### 3.12 Transport and Roads

**HINZE DAM STAGE 3 EIS  
SUPPLEMENTARY REPORT**

■ **Figure 21 Alternative Access Typical Cross-section**

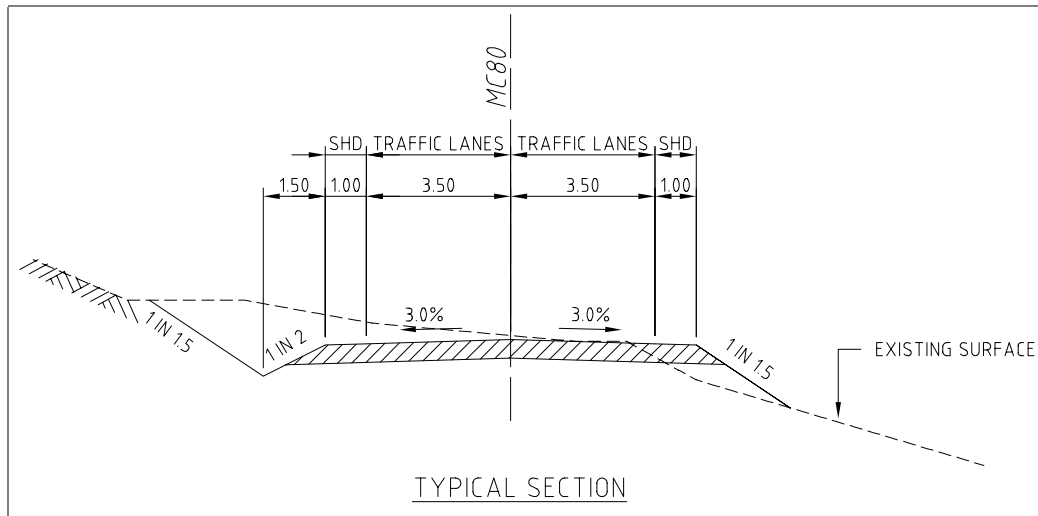
**Figure 21** illustrates the typical cross-section that was adopted, consisting of a 2-lane 2-way semi-rural carriageway of 3.5m lanes and 1m shoulders. The shoulders widen out to 2m where guardrail exists to allow for a 1m clear zone behind.

**Alternative Access  
Investigated Alignment**

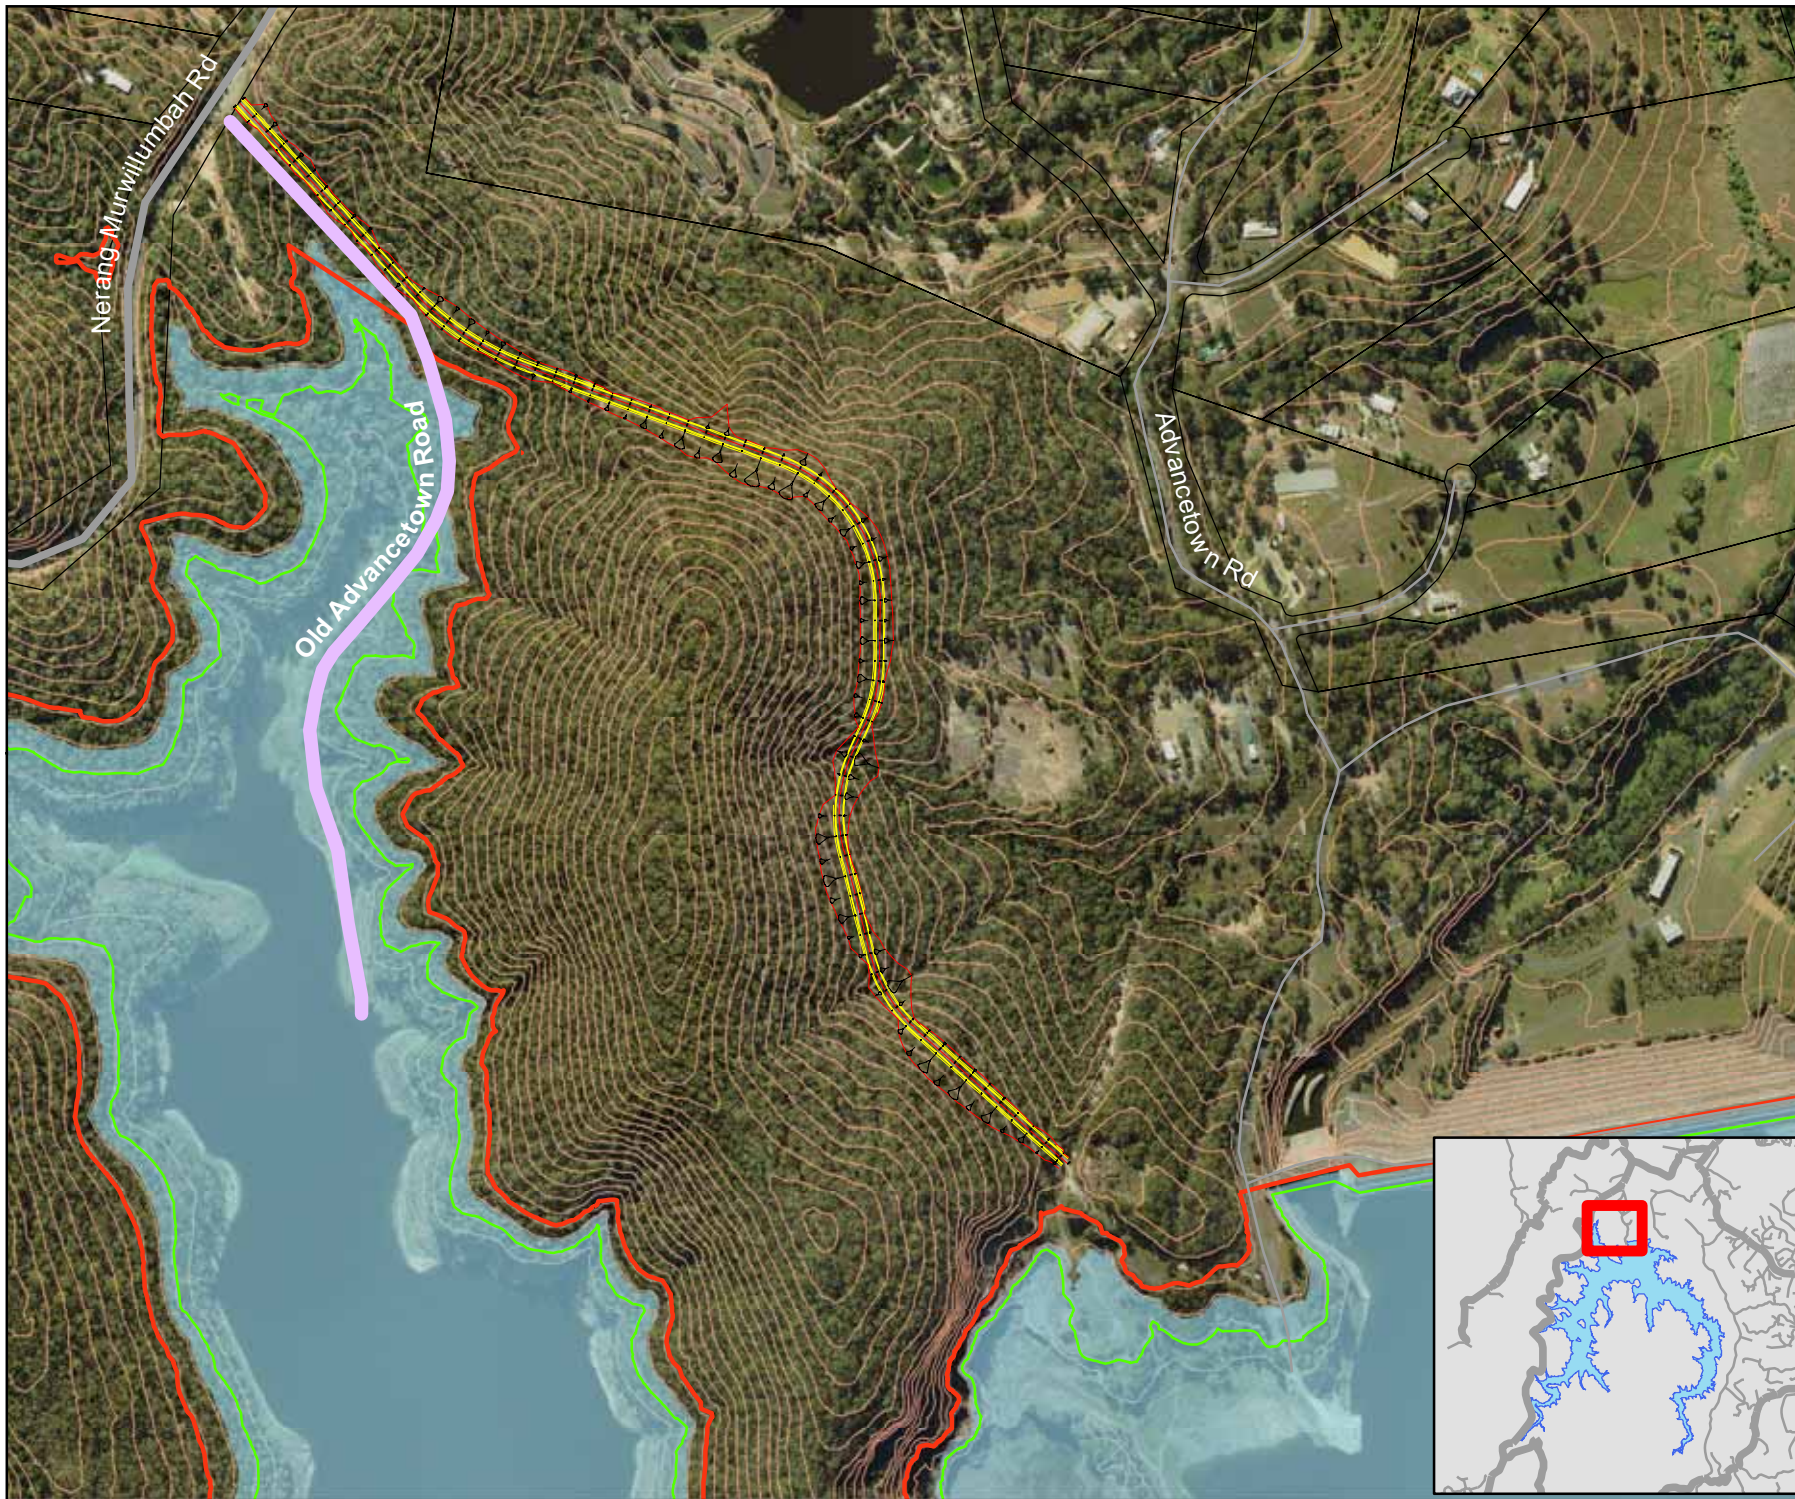
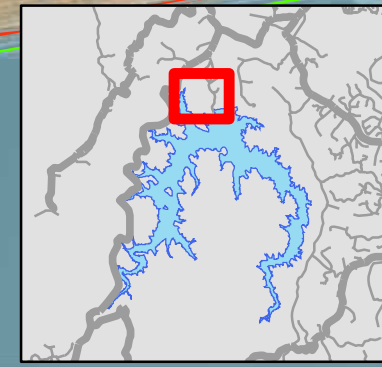
The alignment runs parallel to Old Advancetown Road for approximately 250m after which it deviates east to cross the saddle and follow the contours to the proposed western saddle dam. The use of the Old Advancetown Road was not feasible as the road quickly enters into the current Full Supply Level and the extremely steep topography did not allow for its relocation east up above the proposed new Full Supply Level or 1 in 100 year ARI flood level.

In consideration of the above, the Alliance proposes to maintain the existing access road to the site during construction and upon completion as Advancetown Road. The residents in the area will be consulted during the design of the road upgrade works to allow input into the final configuration.

■ **Figure 23 Alternative Access Investigated Vertical Alignment**

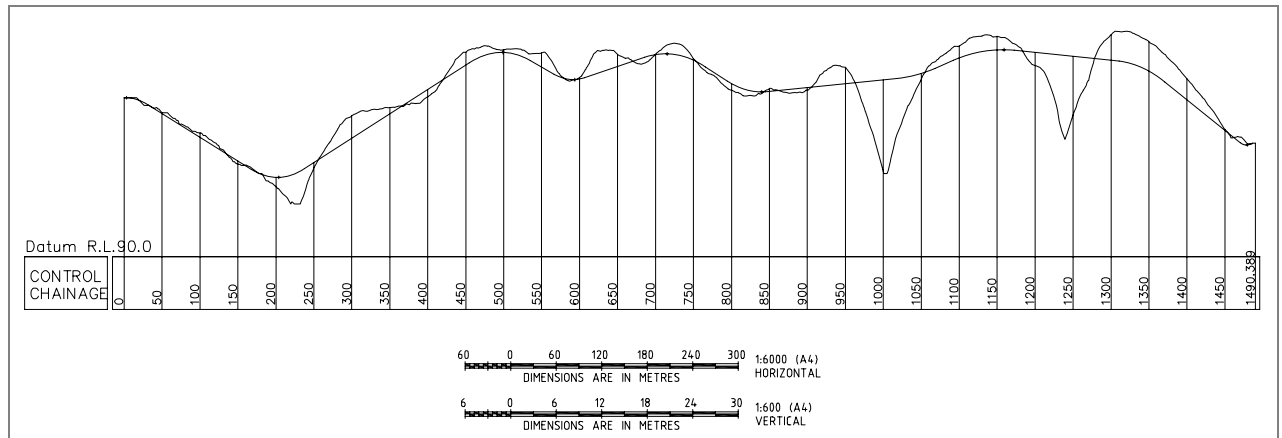
The vertical alignment of the road can be seen in **Figure 23**.

**FIGURE 25**

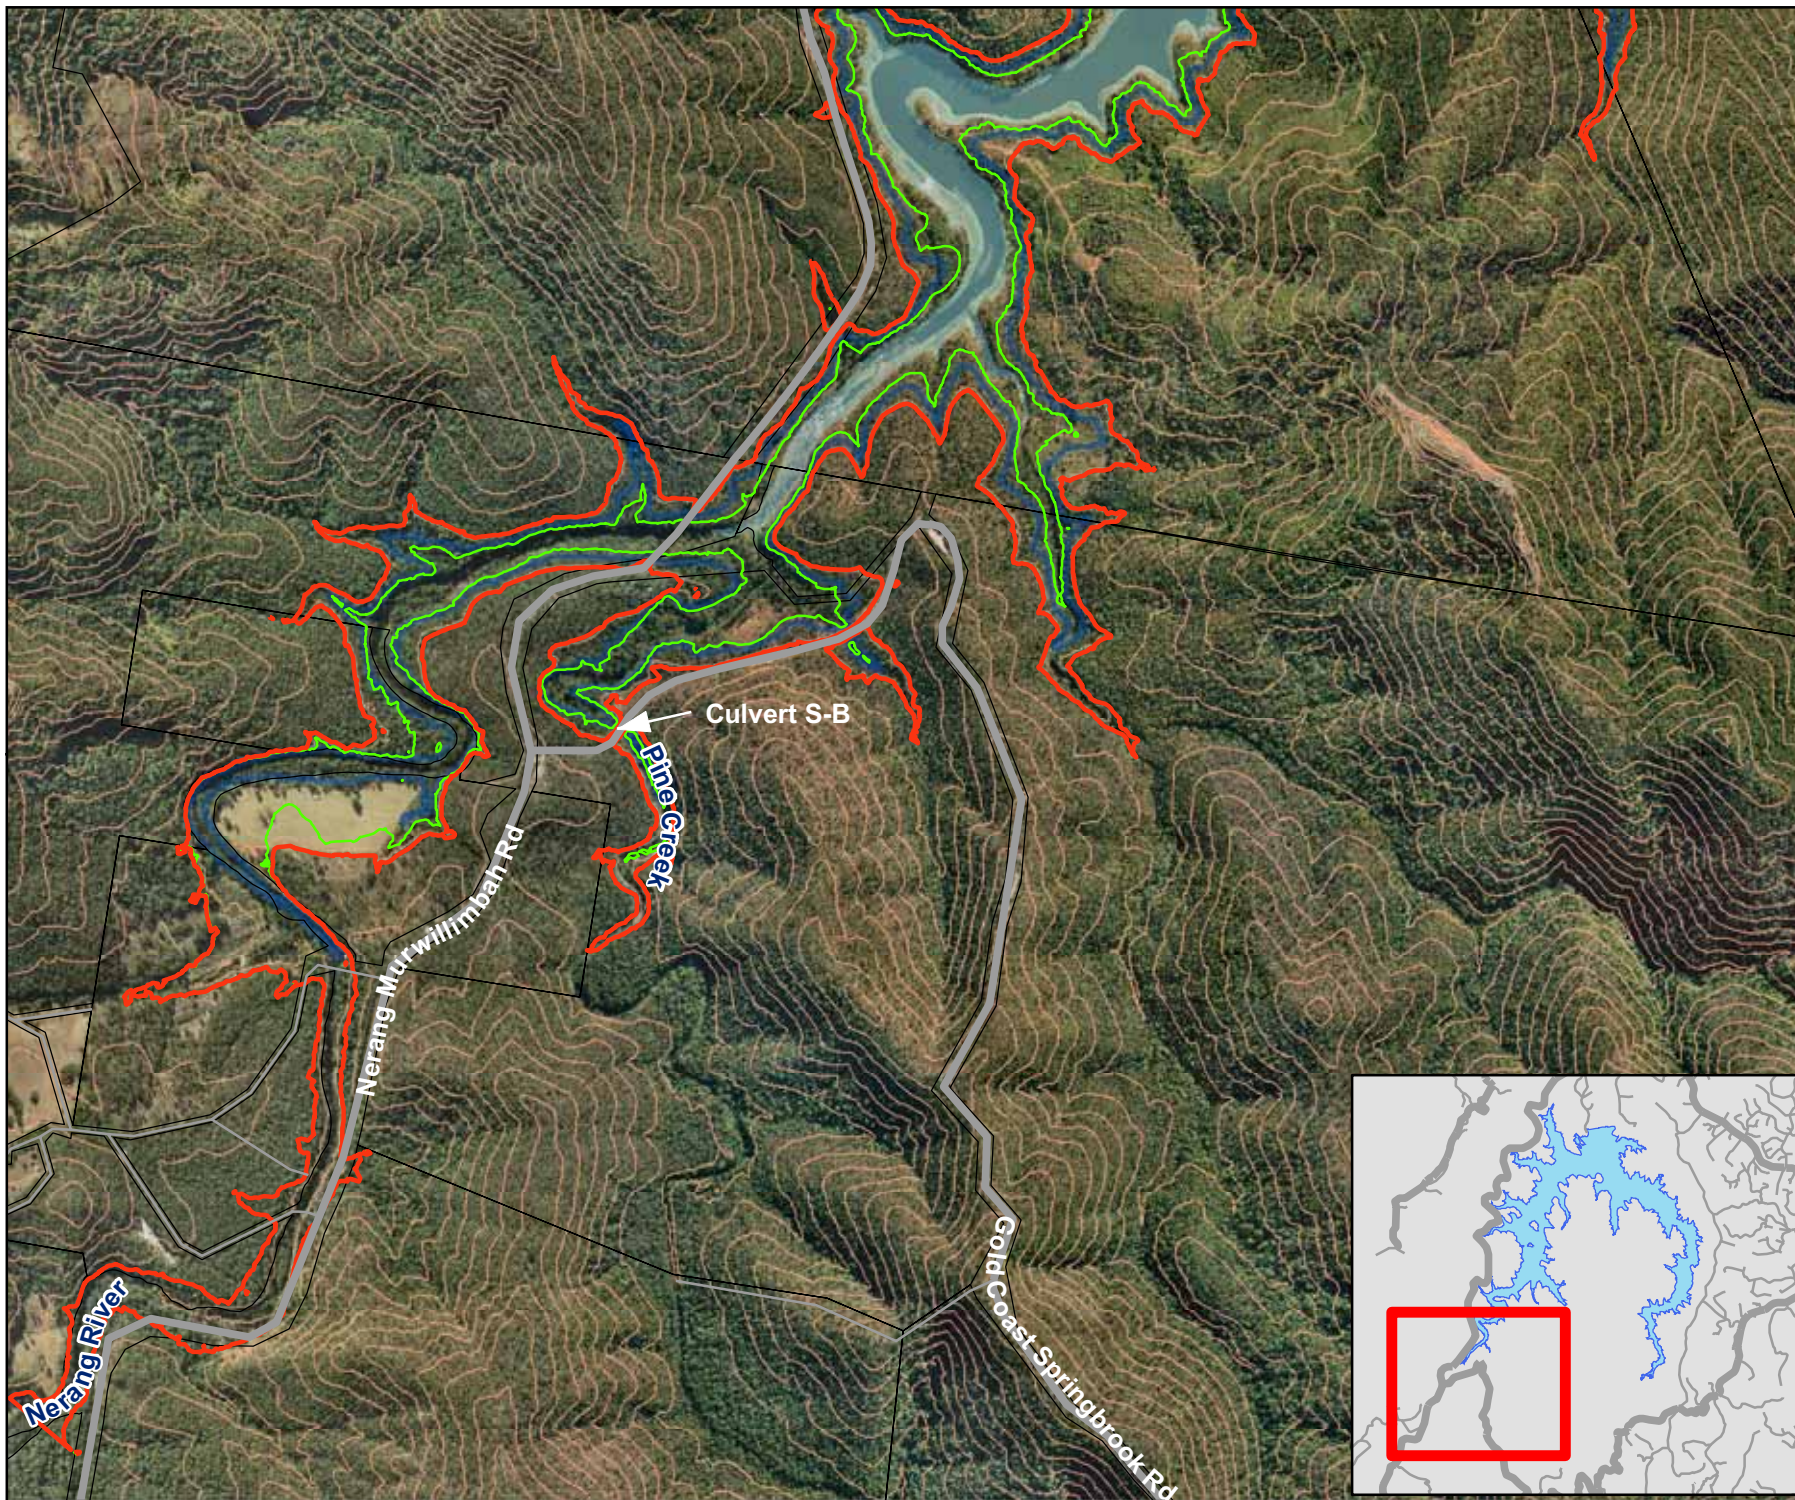
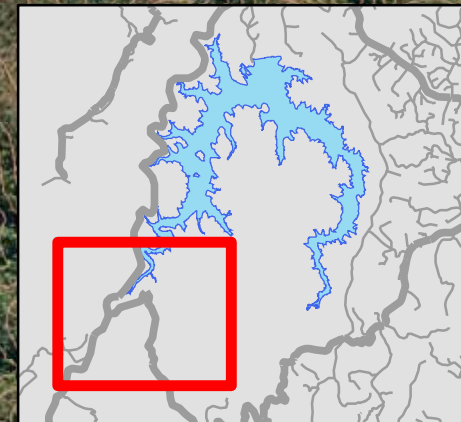
One submission requested the location of culvert S-B. The location of Culvert S-B as discussed in Section 13.6.3 of the EIS is shown in **Figure 25**.
